**JANUARY 2020
STORMWATER INVESTIGATION REPORT
RESPONSE TO COMMENTS
COAKLEY LANDFILL
North Hampton and Greenland
New Hampshire**

**Re: Stormwater Investigation Report – Response to Comments
Coakley Landfill – North Hampton and Greenland, New Hampshire**

**SURFACE WATER EVALUATION
SCOPE OF WORK
COAKLEY LANDFILL SUPERFUND SITE
NORTH HAMPTON
AND GREENLAND, NEW HAMPSHIRE**

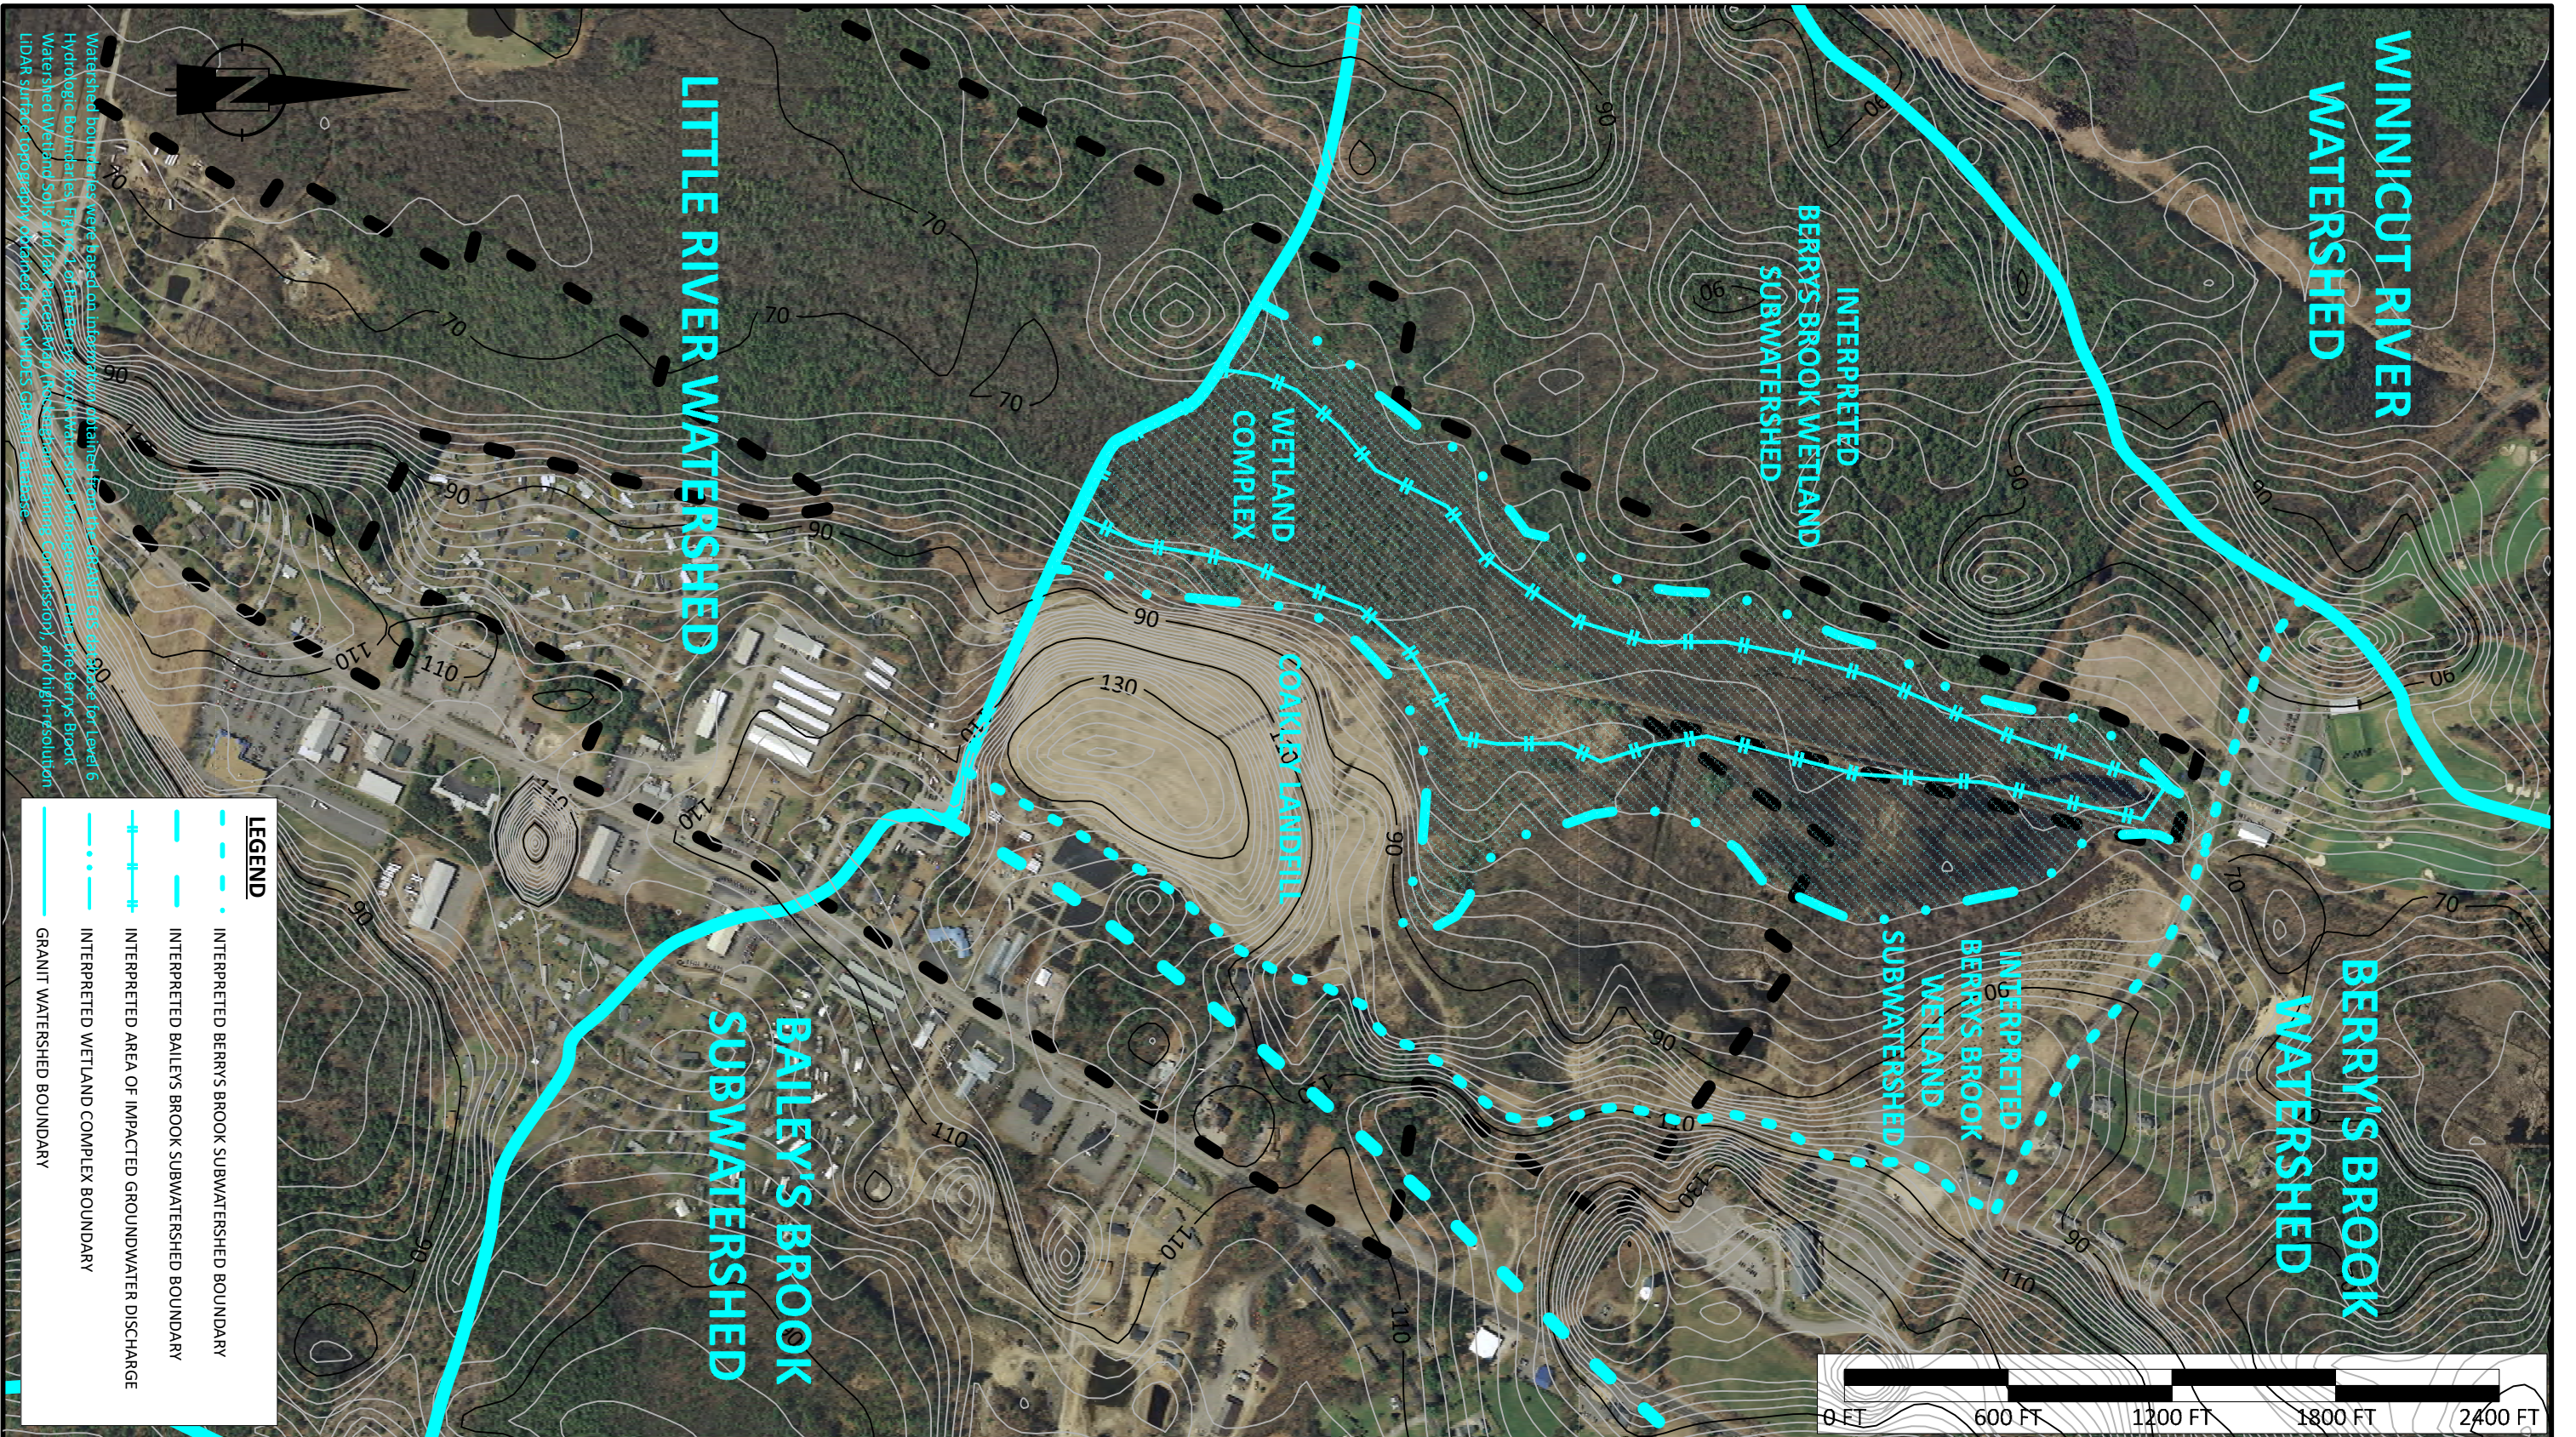
- 1. Water infiltrating within Areas 1 and 2 is collected by the underdrain piping system while water infiltrating in Area 3 enters a gravel-filled toe drain system, but the ultimate discharge location for the toe drain system is not identified.**

- 3. Section 2 describes the perimeter drainage ditches and “rip-rap let-down structures” and cites Figure 1, but the figure does not have the let-down structures labeled. Given that the Stormwater Report references several rip-rap structures, it would be useful to specifically label the let-down structures and toe-drains in Figure 1.**

The location and ultimate discharge locations for the toe drains will be identified on a revised Figure 1 – Stormwater Investigation Sampling Locations included with Attachment A of this letter and used in future reporting.

The referenced rip rap-lined letdown structures referenced in Section 2 will be included on a revised Figure 1 – Stormwater Investigation Sampling Locations included with this letter (Attachment A) and in final reporting efforts. For toe drain locations, see response to USEPA Comment No. 1.
